Access Compliance Report

Public Rights-of-Way

(Curb Ramps)

Intersection ID: 23191	Main Street: ALEXANDER_RD	Cross Street: IRONKETTLE_RD	Location: NW
ADA ID: 23BBACF076C2	Ramp Type: Perp	Initial Pass/Fail: Fail	Overall Compliance: No
			Severity Score: 26.25

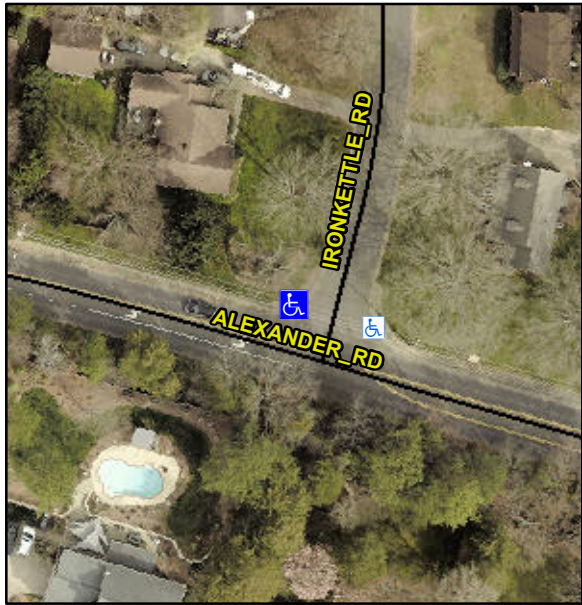
Codes/Mitigation Info/Possible Solution			Field Measurements/Component Compliance					
	Possible Solutions:		Compliance	Description	Data	Compliance	Description	Data
	Remove & Replace Entire Ramp.		N/A	Ramp Length (in)	49.0	No	Ramp Slope (%)	12.0
			Yes	Ramp Width (in)	48.0	No	Ramp XSlope (%)	3.6
			N/A	Flare Type LT	N/A	N/A	Flare Type RT	N/A
			N/A	Flare Slope LT (%)	N/A	N/A	Flare Slope RT (%)	N/A
			N/A	Flare Traversable LT?	N/A	N/A	Flare Traversable RT?	N/A
			N/A	Landing Length (in)	N/A	N/A	DWS Provided?	N/A
			N/A	Landing Width (in)	N/A	N/A	DWS Contrast?	N/A
			N/A	Landing Slope (%)	N/A	N/A	DWS Length (in)	N/A
			N/A	Landing X Slope (%)	N/A	N/A	DWS Full Width?	N/A
Surveyor Notes:			N/A	Landing Curb? (Y/N)	N/A	N/A	DWS Offset (in)	N/A
N/A			N/A	Shared Landing?	N/A			
PROW/ADA:			N/A	Gutter Ponding?	N/A	N/A	Gutter Slope (%)	N/A
Not Found, R304.2.2, R304.5.3			N/A	Gutter Lip Ht (in)	N/A	N/A	Gutter X Slope (%)	N/A
